Access Compliance Report Public Rights-of-Way (Curb Ramps)

Intersection ID: 49136 Main Street: AMBER_LEIGH_WAY_DR Cross Street: POPE_FARM_RD Location: W

ADA ID: 8ECF3D7E6D22 Ramp Type: Perpendicular Initial Pass/Fail: Fail Overall Compliance: No Severity Score: 12.5

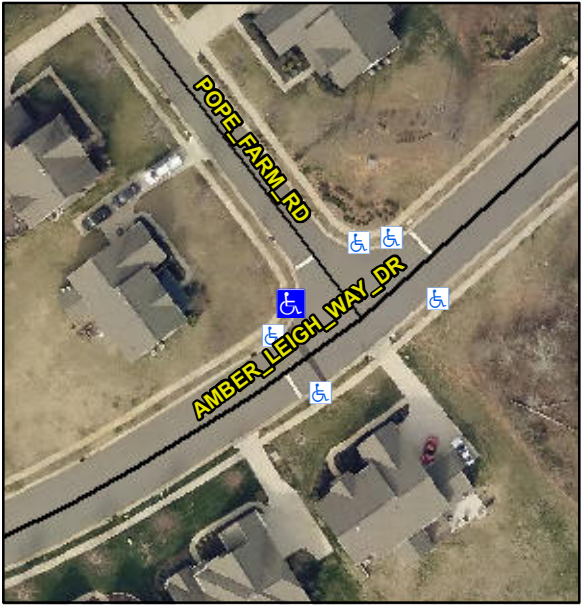
Possible Solutions:
Remove & Replace Entire Ramp.

PROW/ADA:
Not Found, R304.2.2
